TI_2122: Connector latch for I/O board

iCombi Pro / Classic

12/10/2021

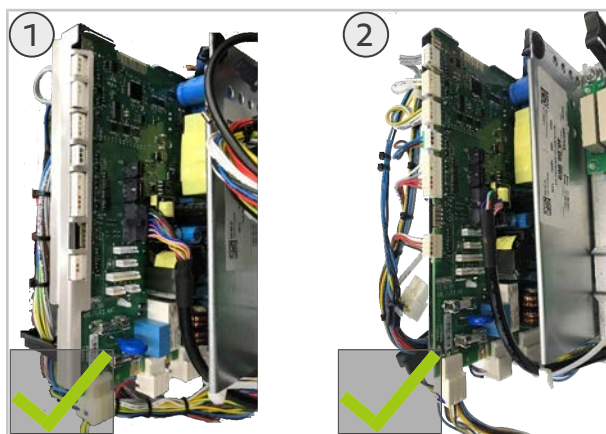
Due to the globally strained delivery situation of coded plugs, uncoded plugs will be installed in isolated units from 01/09/2021.

To ensure that the connectors are still in the correct position on the I/O board, a connector latch is also attached to guarantee the exact position of the connector.

This has no impact on the function of the units.

1. With connector latch for I/O board
2. Without connector latch for I/O board

>> Both variants are available on the market and are correct.
